Agenda Item 4
611 East Woodland Road
Front Porch Alterations and Landscaping

STAFF REPORT AND RECOMMENDATION

TO:	Chairman Grinnell and members of the Historic Preservation Commission
DATE:	May 22, 2024
FROM:	Abigail Vollmers, Senior Planner
SUBJECT:	611 East Woodland Road, Entrance Porch Alteration

Agenda Item 5
464 Oakwood Avenue
Removal of a Chimney

ENTRANCE PORCH
PROPOSED COURTYARD ELEVATION
1/8" = 1'-0"

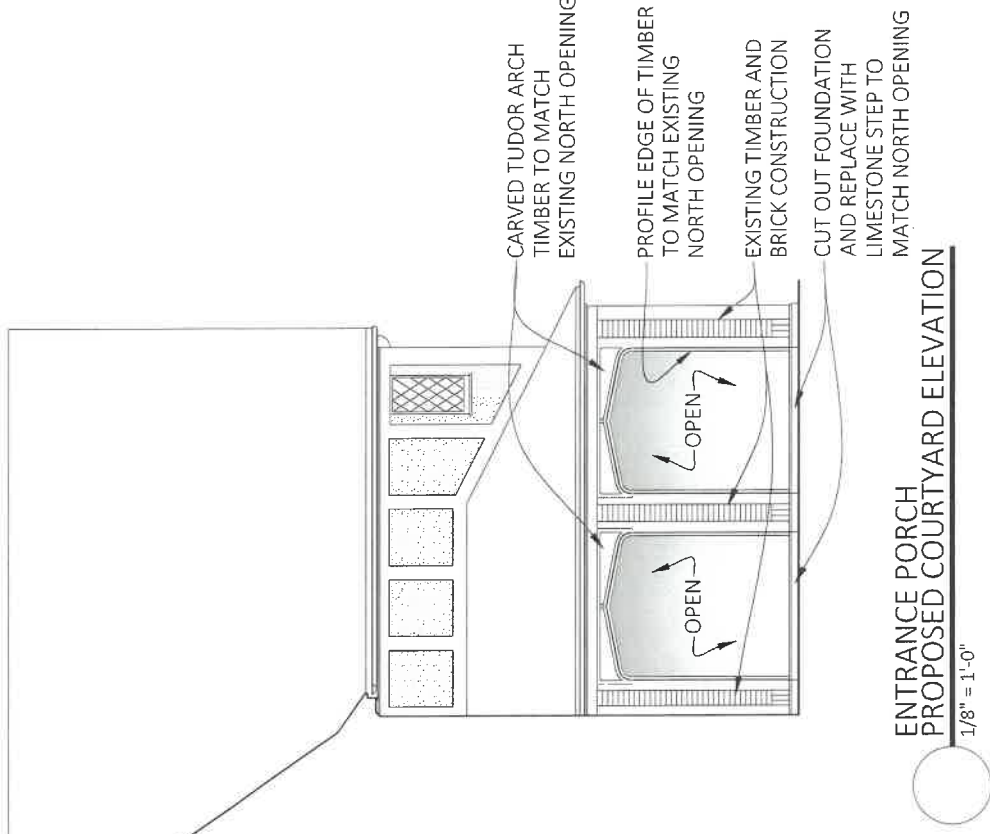
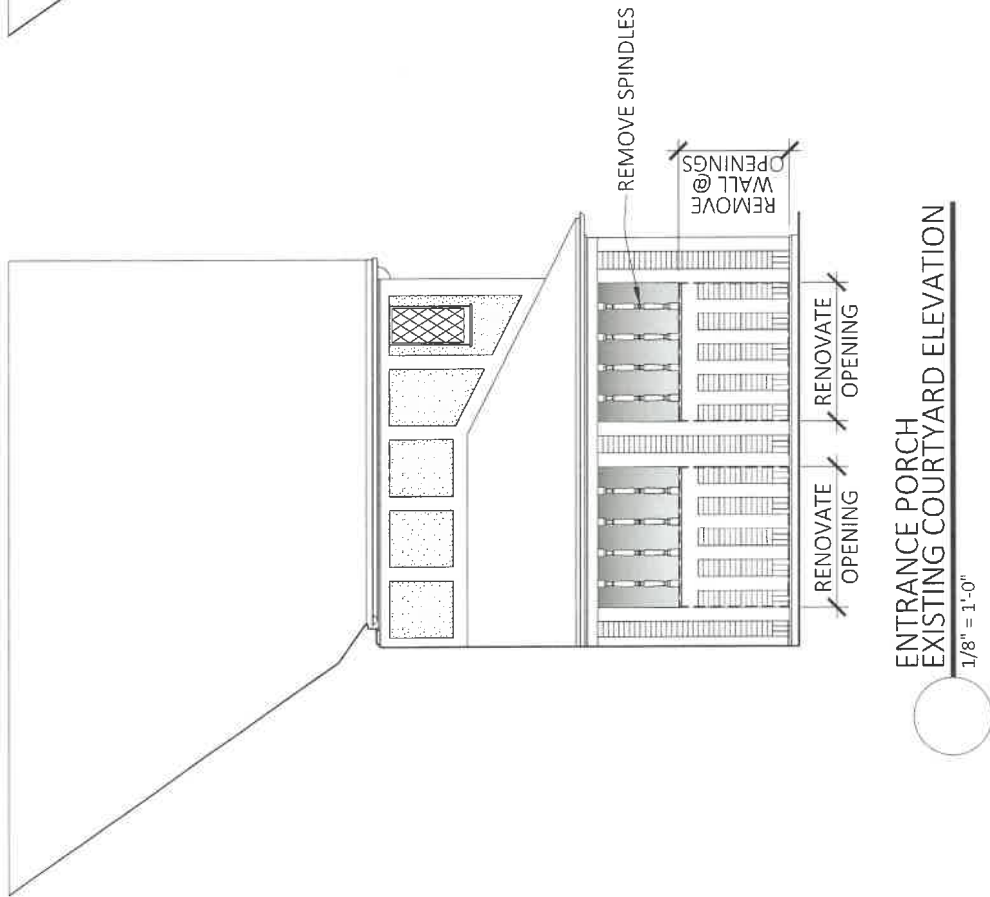
The proposed modification is to remove the lower brick sections and balustrades of the side wall. The middle vertical beams will remain, and the openings will receive arches to match the front. On the front elevation the small open area on either side of the existing archway will be bricked in to match the existing condition on the side wall thereby eliminating two half balustrades and the open space between them.

This standard is met. The new openings respect the existing spacing established by the vertical beams in the middle of the side wall.

The standard is met. The proposed wood arches will match the type and texture of the existing arch material. The brick infill on the front elevation will match the type and arrangement of the existing stacked brick.

This standard is met. The proposed changes will affect the timbers which are a distinctive architectural feature of the front porch in a sensitive way. The joints where the horizontal beams interact with the vertical beams are an enlarged notch that currently allows the horizontal members to soundly sit between the vertical beams. When the horizontal members are removed, the notches will be patched with wood. The patches will enable the existing vertical members to remain in use. The ornamental distressing of the wood timbers implies a high level of craftsmanship in the original construction of the house, and the architect has called for a similar treatment to ensure that the patches are compatible with the existing beams.

○ EAST WALL OF ENTRANCE PORCH - PROPOSED

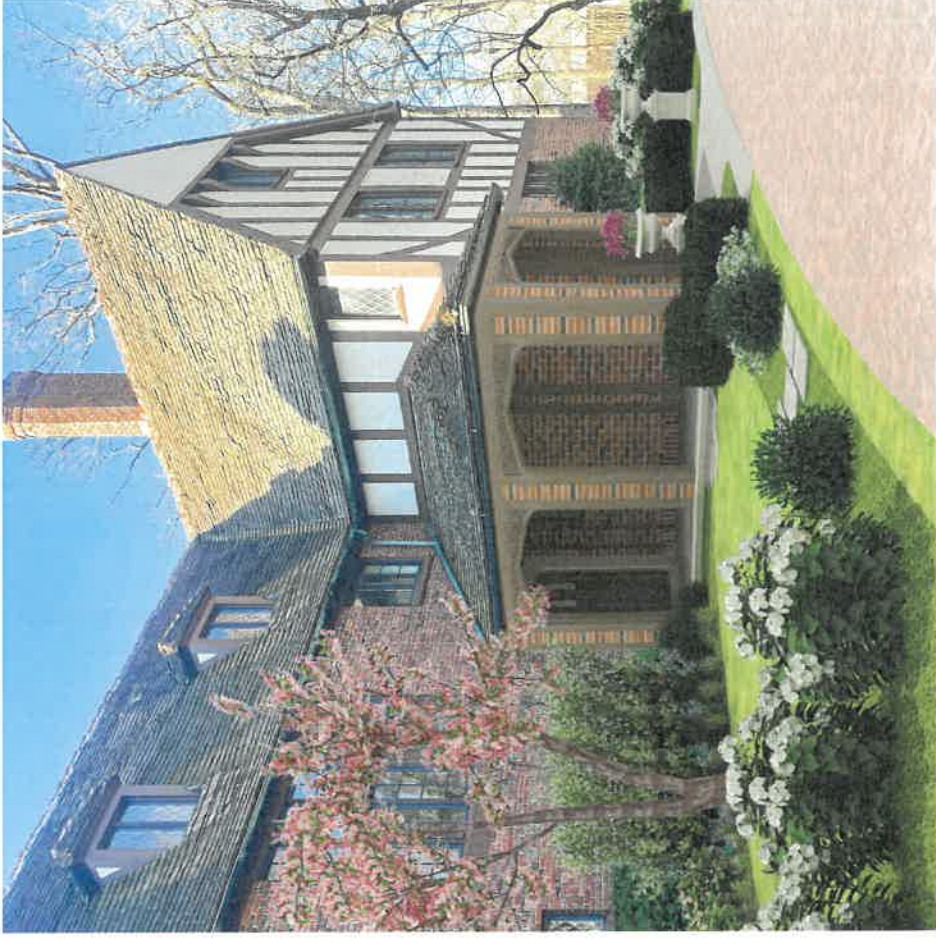
The removal of the balustrades is not significant as they appear to have been added to keep the screens in place when the space was a fully screened porch and don't relate to any other architectural feature on the house.

This standard can be met. Proposed modifications may be able to incorporate the reuse of materials removed from the side walls. Every consideration should be given to repurposing both the horizontal beams as well as the removed bricks in the alterations.

PROPOSED STREET ELEVATION – chimney removed

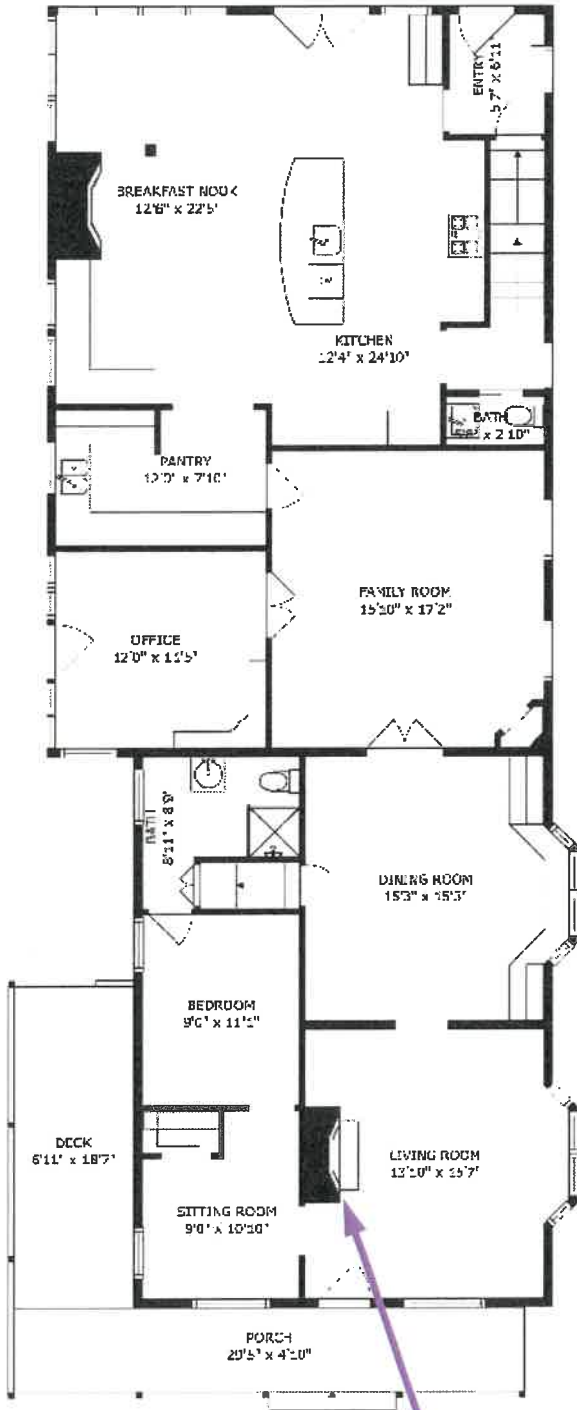
This standard is not met. The proposed change will alter the appearance of the house in a minor way. The question being whether this decision warrants a strict adherence to the standard or an interpretation of the standard recognizing that the removal is an improvement to the functionality of the house.

If the chimney is evaluated on the grounds of whether it improves the look of the house, the off centered placement stands out immediately against the well-ordered elements and details of the home, and the utilitarian look does little to further recommend it. The home would benefit from a correctly placed and architecturally pleasing chimney, but that is not what is currently on the house.

This standard is not met. The modification will remove an original element visible from the streetscape that will not be easy to replace.

FRONT ELEVATION
SCALE: 1/4" = 1'-0"

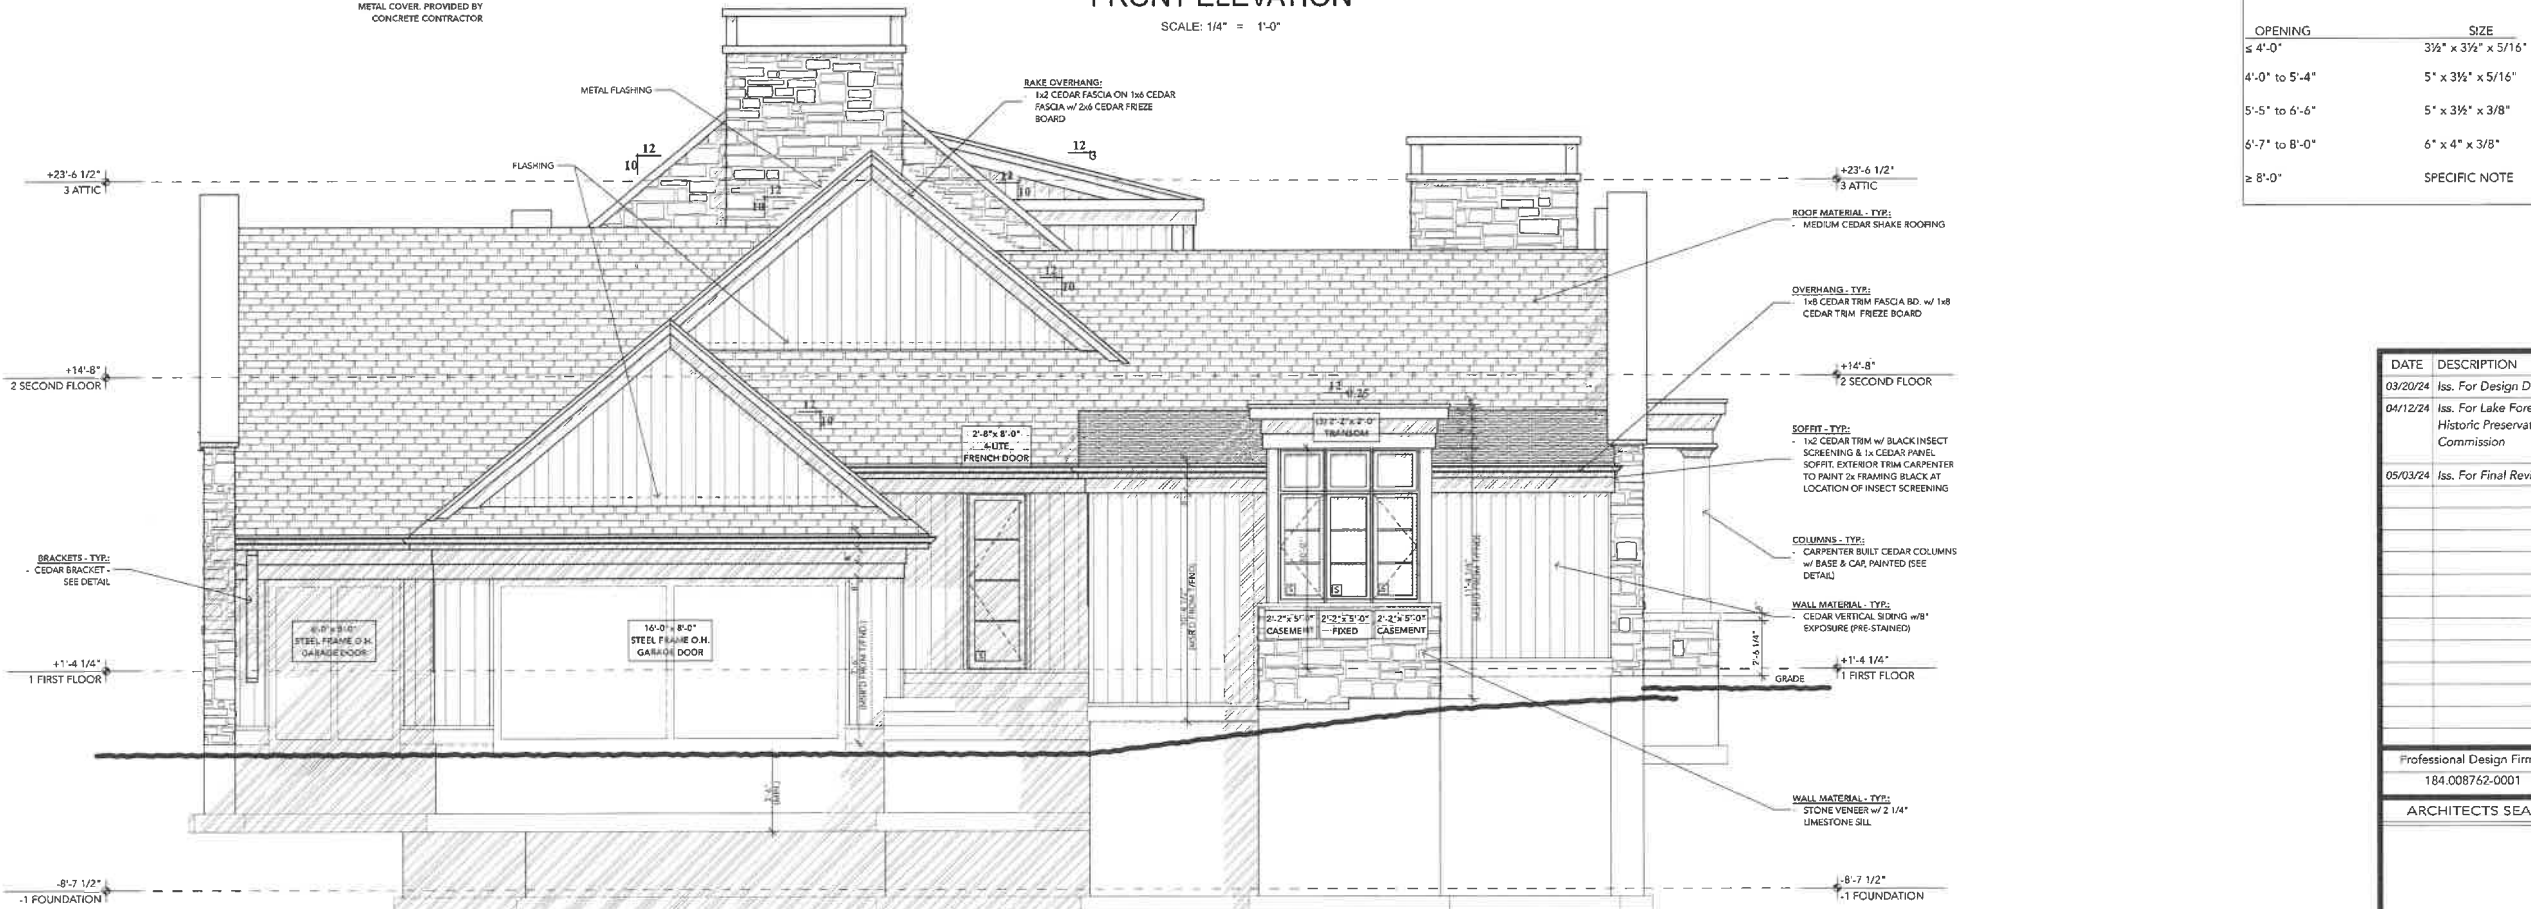
This standard is met. The window walls form secondary planes that complement the large strong masses of the gable ends and break walls. Each gable end is punctuated by a set of double casement windows, and the center gable contains the front door. The tops of the end gable windows align with the top of the window walls establishing a clear datum line across the whole house.

This standard is met. The west elevation is punctuated with a box bay window and punched openings on either side. The front elevation gable ends are visible in a stepped progression which add to the visual interest.
